# City of Capitola

## Planning Commission Meeting Agenda

### Thursday, July 21, 2022 – 7:00 PM

### **A. Blanket CDP and Design Permit for Prototype Street Dining Deck in Central Village**

SHEET **L-1.1**

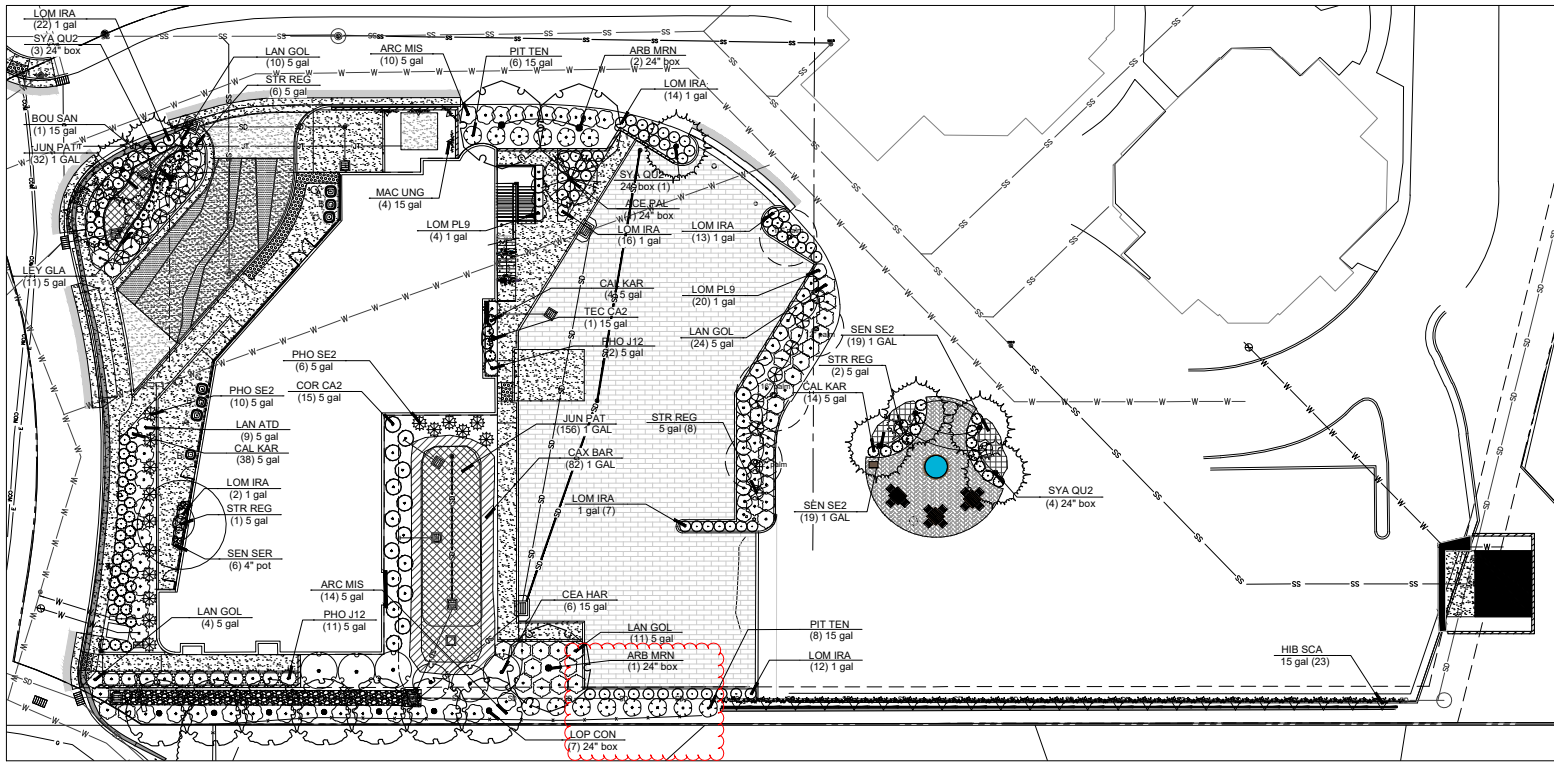
- *Applicant has sufficiently addressed the previous comment by integrating a variety of fast-growing, larger, evergreen sized landscaping along the southern property line, as noted on Sheet L-1.1.*

- *Per Sheet L-1.1, applicant has identified Cat's Claw Creeper vine at wall adjacent to transformer at internal drive. However, Detail 3 on Sheet L-1.4 notes vine to attach to wall. Applicant should verify that vine is able to attach and be maintained at retaining wall without assistance and that ultimate height of vine is sufficient to screen views of adjacent transformer at internal drive.*

**JOB NO.** 202103  
**SCALE** 1/16" = 1' - 0"  
**DRAWN** MA  
**CHECK**  
**DATE** 7.1.2022  
**SHEET** L-2.0

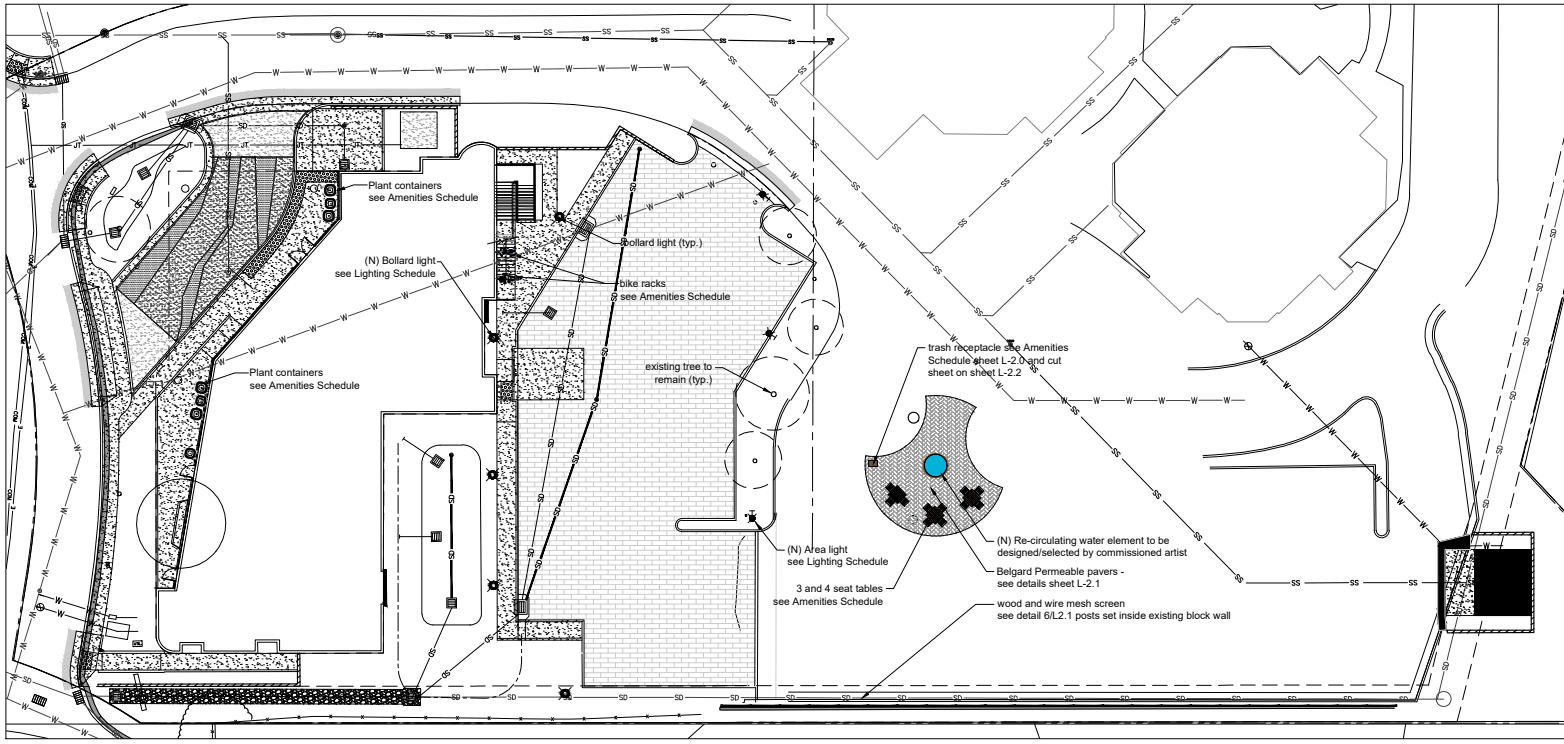
- *The applicant has addressed the previous comment. Light fixtures are identified on Sheet L-2.0 and are considered consistent with the overall project design direction.*

- *Per Sheet L-2.0, selected light fixtures are shown as shielded and to be directed downward, consistent with CMC 17.120.070.Q.*
24. Acknowledging utility provider setbacks from their facilities, the applicant should incorporate architectural enclosures, fencing, landscaping, and/or other design interventions to screen these areas from view (CMC 17.120.070.S).
